78 New Oxford Street 2022/5605/P

Delegated Report		Analysis sheet	Expiry Date:	16/02/2023
(Members Briefing)		N/A / attached	Consultation Expiry Date:	19/03/2023
Officer			Application Number	
Edward Hodgson			2022/5605/P	
Application Address			Drawing Numbers	
78 New Oxford Street London WC1A 1HB			<i>See draft decision notice</i>	
PO 3/4	Area Team Signature	C&UD	Authorised Officer Signature	
Proposal(s)				
Replacement of existing cladding on all floors, alterations to windows and office entrance, installation of new window at ground floor, new plant area at roof level and installation of louvres on all levels				
Recommendation:	Grant conditional planning permission			
Application Type:	Full Planning Permission

Replacement of existing cladding on all floors, alterations to windows and office entrance, installation of new window at ground floor, new plant area at roof level and installation of louvres on all levels

1. Aerial photo of the application site and wider context including the existing rooftop plant

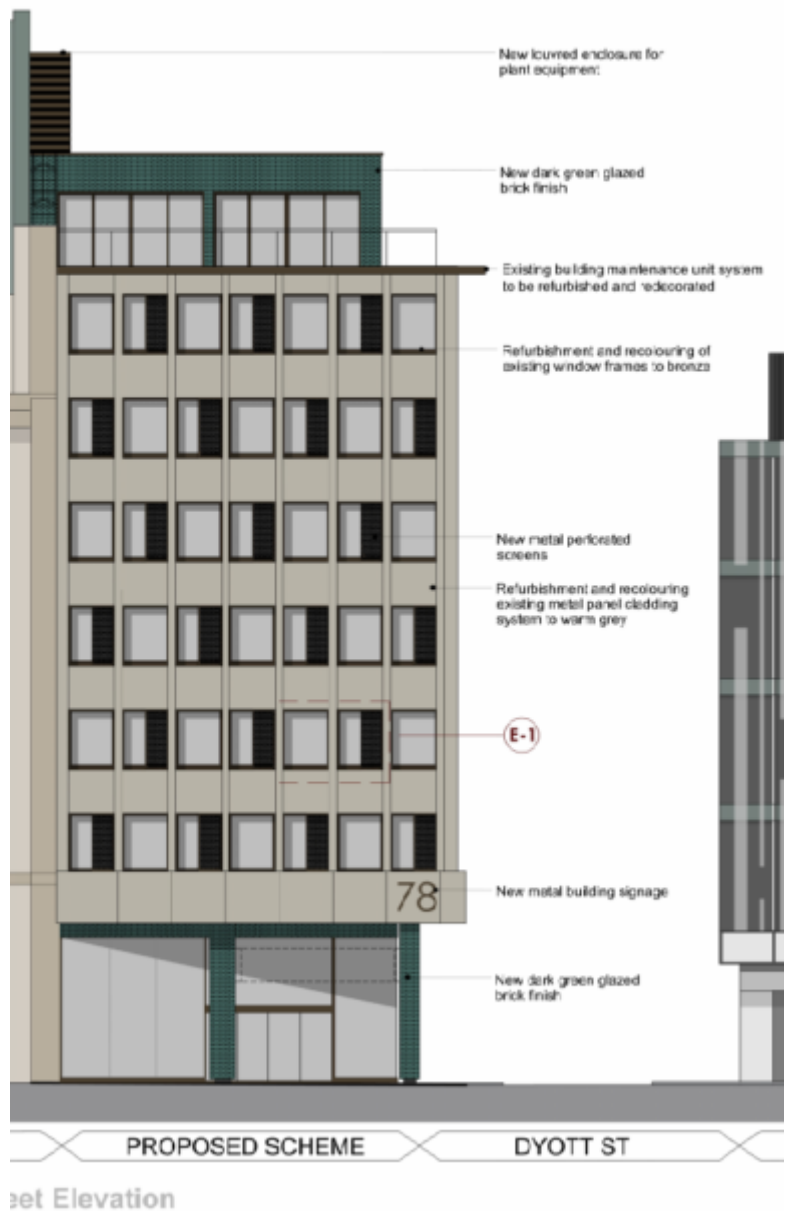
- 2.5. The proposed replacement plant at roof level would be located within a bronze metal acoustic enclosure. It would be set back significantly from the front and side elevations and set back from the rear elevation. It would therefore have limited visibility from the public realm and from views within the conservation area. There is already a proliferation of rooftop plant, at roof level and the proposal would combine this into a more rationalised enclosure. The proposed roof plant is thus considered acceptable.

3. Photo of existing Bainbridge Street Elevation

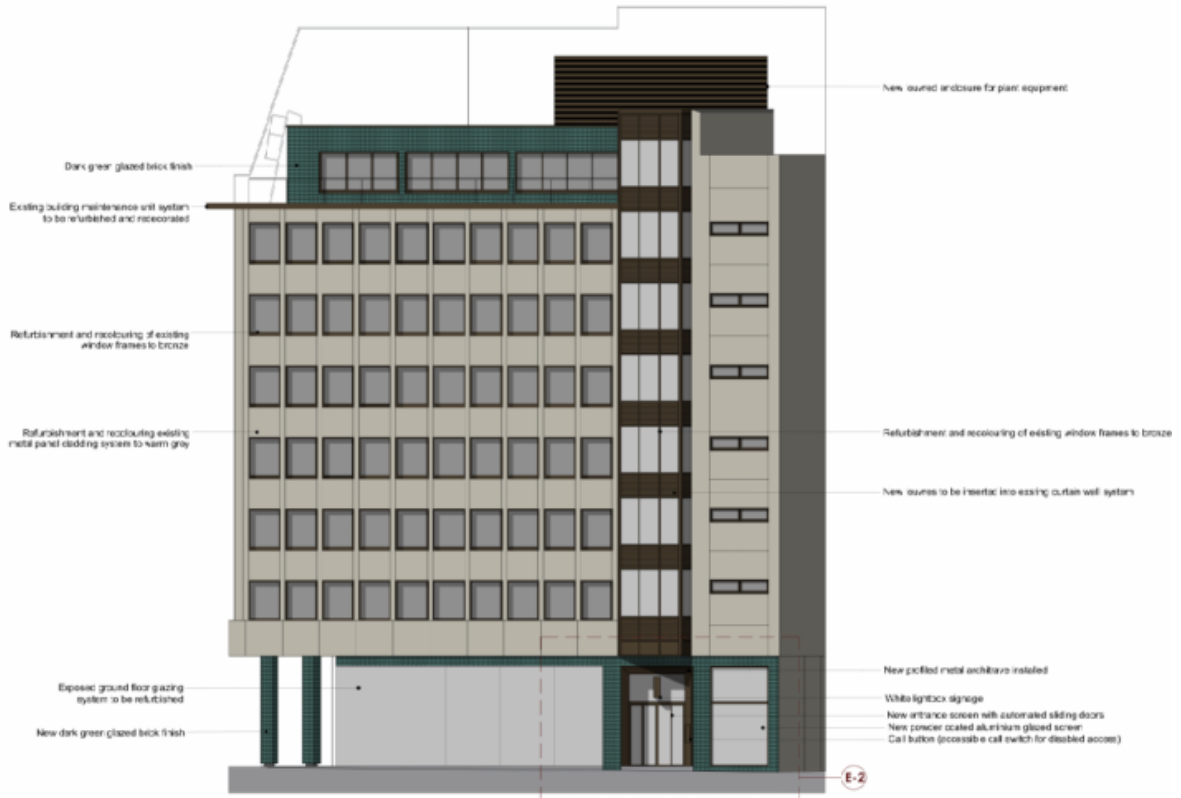
- New louvres are proposed at levels one to seven.
- The only alterations to the rear (Bainbridge St) elevation would be the green tiling.
- At roof level, a replacement plant consisting of 14 new condenser units would be installed within acoustic enclosures.
